Mohsin Knitwear Ltd.

B 361-364 BSCIC I/A
Enayetnagar, Fatullah, Narayanganj
(23.624188N, 90.481758E)
21 October 2015

Observations

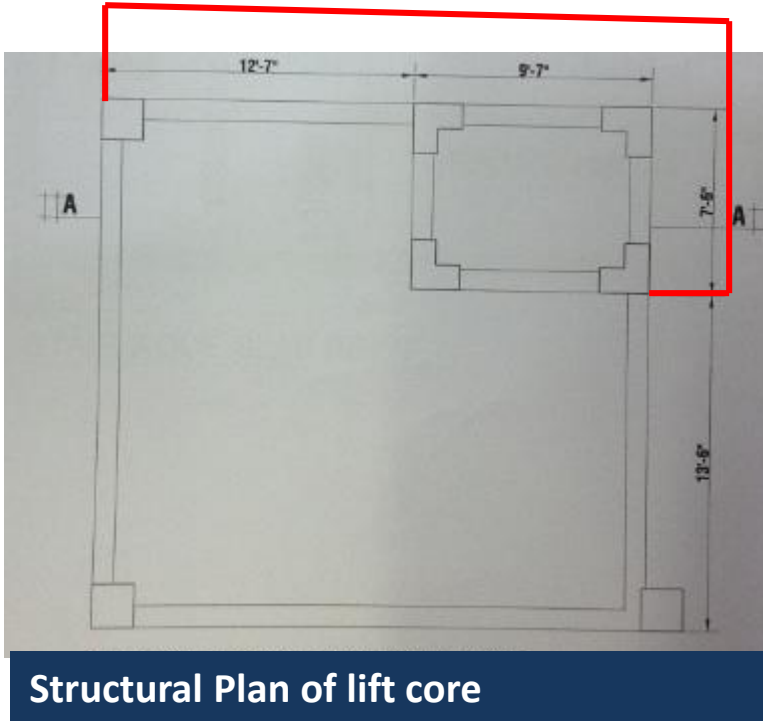
Floor loading uncontrolled

6th Floor cotton bags in cantilever section of the floor

1st Floor storage in cantilever areas

6th Floor storage in centre of floor full height

4th Floor, storage in cantilever section of the floor

1st Floor storage in centre of floor full height
